UNITARY PLAN UPDATE REQUEST MEMORANDUM

SUBJECT **Plan Modification to the Auckland Unitary Plan(AUP)
Operative in part (15 November 2016)**

Reason for update – to make Plan Change 76 operative	
Chapter	Chapter I Precincts Chapter L Schedules GIS Viewer planning maps
Section	Chapter I Precincts South I453 Pukekohe East-Central Precinct Chapter L Schedule 3 Significant Ecological Areas – Terrestrial Schedule GIS Viewer planning maps: <ul style="list-style-type: none"> • Zones • Precincts • Significant Ecological Areas Overlay
Designation only	
Designation #	Name & RA
Locations:	
Lapse Date	
Purpose	
Changes to text (shown in underline and strikethrough)	Amendments are required because Private Plan Change 76 Kohe is to be made operative. Chapter I: Add new precinct into Chapter I Precincts South I453 Pukekohe East-Central Precinct as shown in Attachment 2 Chapter L: Add new significant ecological area (ID SEA_T_9105) to Schedule 3 Significant Ecological Areas – Terrestrial Schedule as shown in Attachment 3
Changes to diagrams	Chapter I: Add new precinct plan into Chapter I Precincts South I453 Pukekohe East-Central Precinct as shown in Attachment 2

Attachment 1: PC 76 Decision

Attachment 4: Updated Zone change

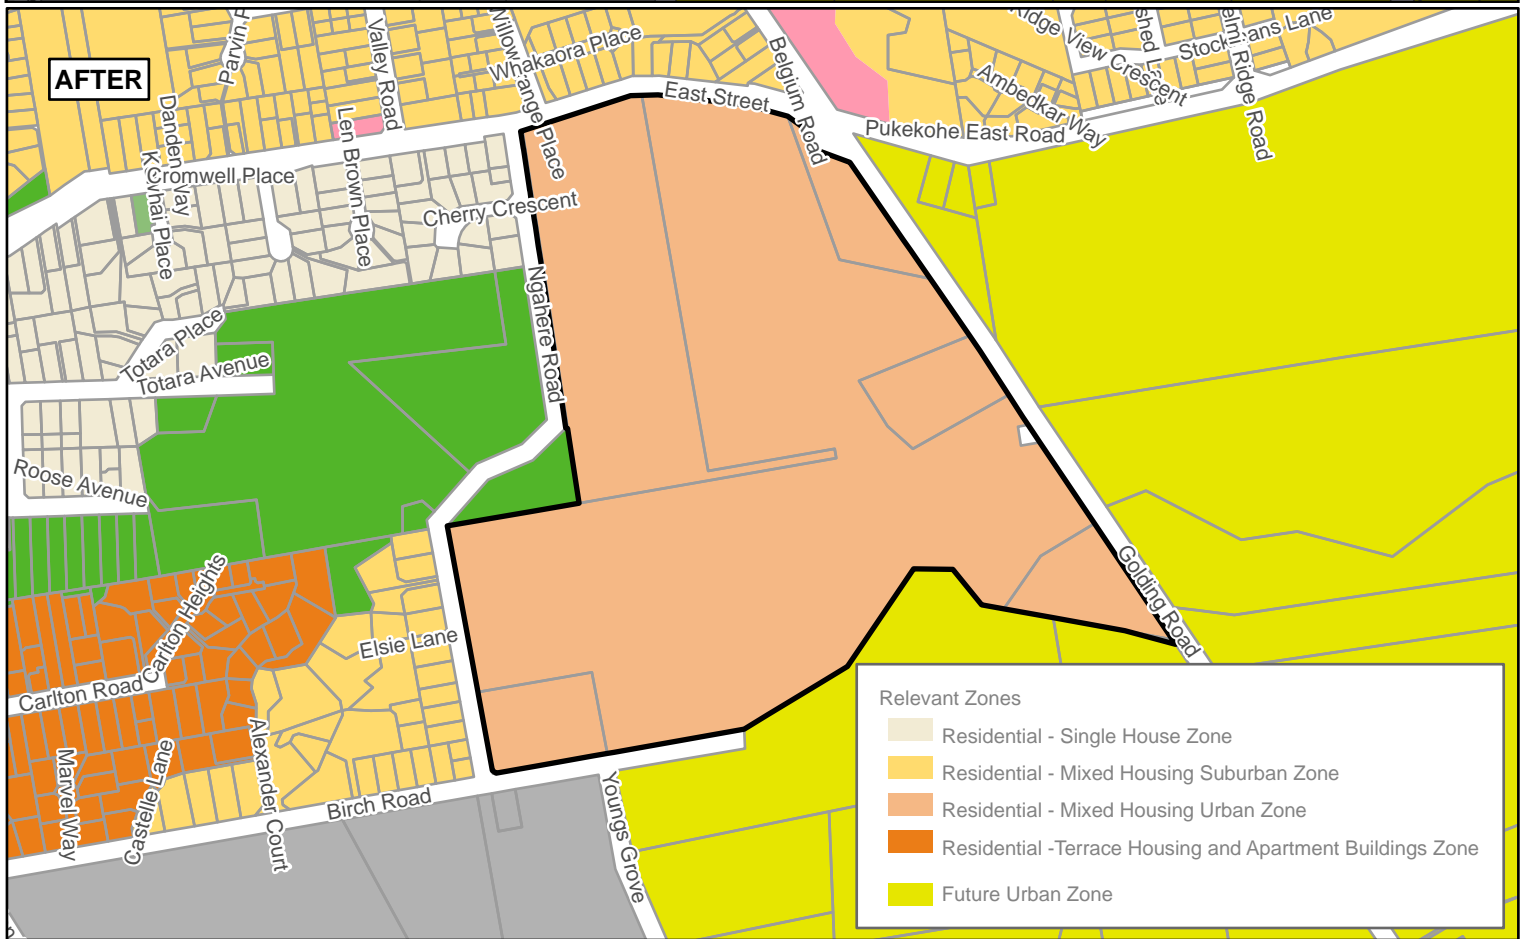
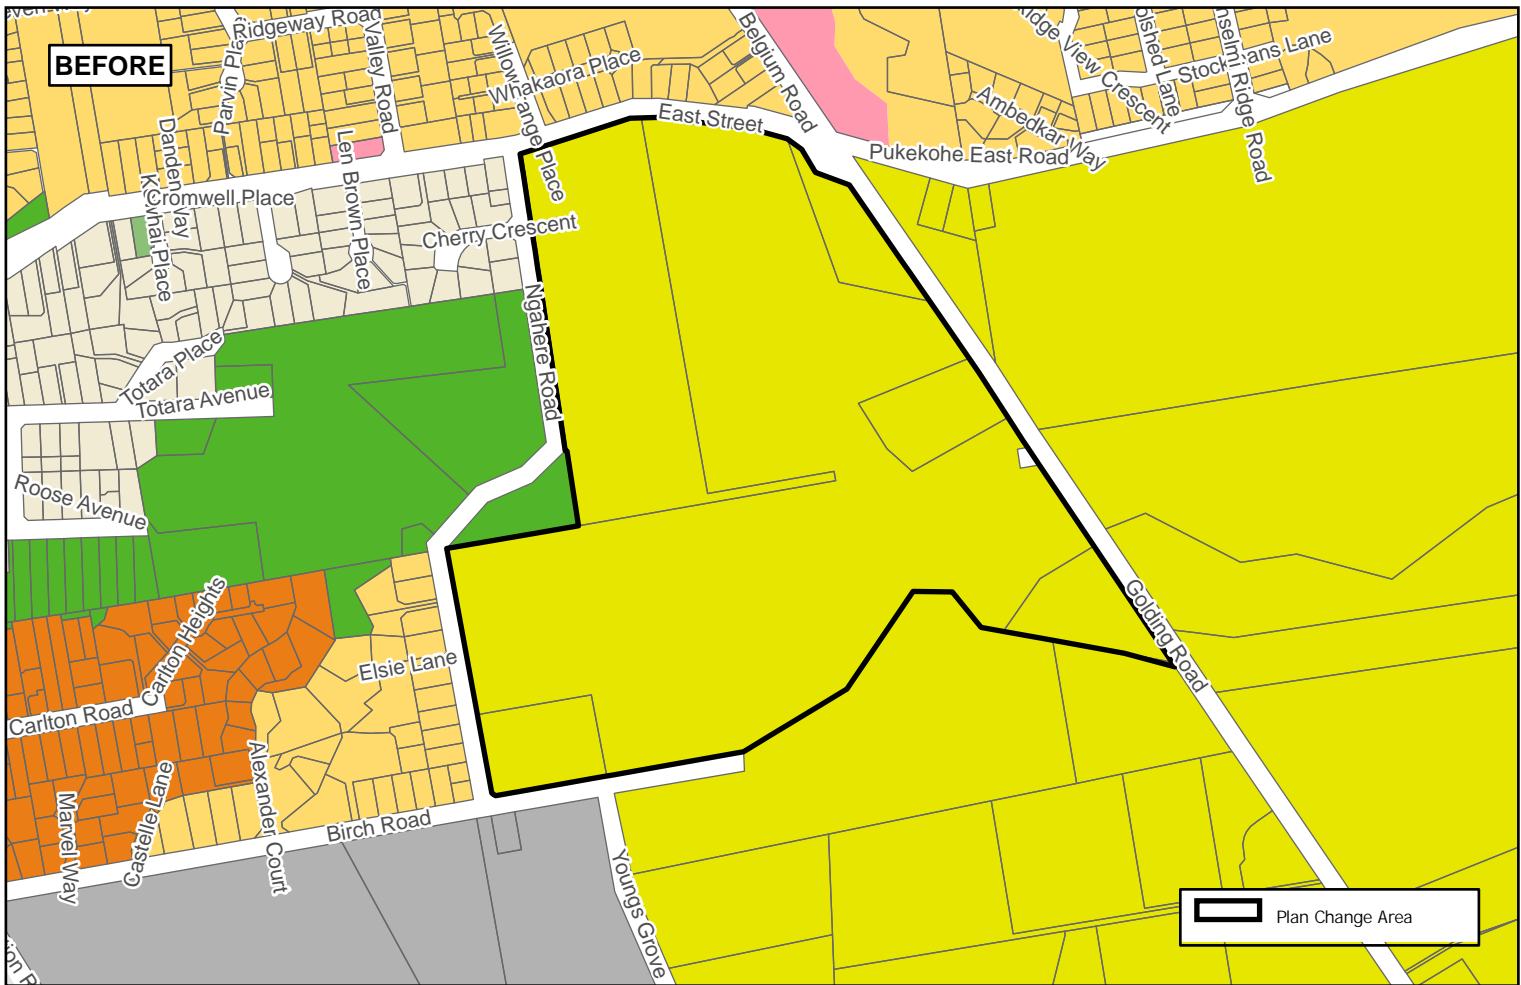
Changes to spatial data	Amend GIS Viewer planning maps: <ul style="list-style-type: none"> • Unitary Plan Zones – rezone approximately 30 hectares from Future Urban Zone to Residential – Mixed Housing Urban as shown in Attachment 4 • Unitary Plan Zones – rezone 2m wide strip along eastern side of Ngahere Road

<p>from Open Space – Conservation to Residential – Mixed Housing Urban as shown in Attachment 4.</p> <ul style="list-style-type: none"> • Unitary Plan Management Layers Precincts – add new Pukekohe East-Central Precinct as shown in Attachment 5. • Unitary Plan Management Layers Overlays – add new significant ecological area to Significant Ecological Areas (SEA) Overlay as shown in Attachment 3.
Attachments	<p>Attachment 1: PC 76 Decision Attachment 2: New Pukekohe East-Central Precinct text Attachment 3: SEA Overlay Attachment 4: Updated Zone change Attachment 5: Precinct before and after map Attachment 6: Clause 20A</p>

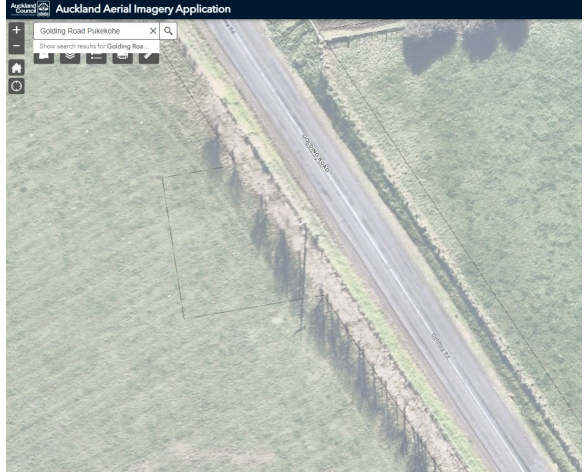
Rule or Section of Unitary Plan	GIS Viewer – zone planning maps
Subject Site (if applicable)	Small portion of road on the western side of Golding Road, Pukekohe (between 26 and 52 Golding Road)
Legal Description (if applicable)	Null
Nature of change	<p>A Clause 20A modification is required to correct a minor mapping error in the AUP, resulting from a minor error in the Decision on Plan Change 76 (PC76).</p> <p>Discussion PC76 is being made operative in the AUP at the same time as this clause 20A is being made. The Decision on PC76 included a minor mapping error to the extent of the area being rezoned as Residential – Mixed Housing Urban (MHU) Zone. This mapping error was also included in the Planning Environment and Parks Committee reporting (29 June) where the council approved the plan change to be made operative.</p> <p>The PC76 Decision zone map shows a small portion of road on the western side of Golding Road (between 26 and 52 Golding Road, Pukekohe) as being rezoned to MHU Zone. This is incorrect as this is still legally a road and cannot be rezoned until the road is stopped.</p> <p>Amend the AUP to revert this small portion of road back to road i.e. remove the MHU Zone as shown below.</p>

<p>Area within purple line to be rezoned Mixed Housing Urban through PC76</p> <p>Retain green hatched area as road i.e. do not rezoned to Mixed Housing Urban</p> <p>Auckland Council Plans and Places, public</p>
<p>Effect of change</p>	<p>The correction noted above:</p> <ul style="list-style-type: none"> • is to correct a minor error • is neutral (it would not affect the rights of some members of the public) <p>The small portion of road in question is owned by Auckland Transport and appears to be an unformed road. See aerial below.</p>

<p>Before any road land can be stopped, Auckland Transport needs to confirm the road is no longer required for transport purposes and carry out the necessary road stopping processes which are governed by either the Local Government Act 1974 or the Public Works Act 1981.</p> <p>Once a road has been officially stopped and council receives updated GIS data from LINZ any stopped road will be automatically given the same zone as that of the adjoining site – see AUP E26.2.3 Note (4).</p>
Changes required to be made (text/in-text diagrams)	NA
Changes required to be made (maps)	Amend the extent of the MHU Zone so it does apply to the portion of road as shown in Attachment A.
Attachments	NA
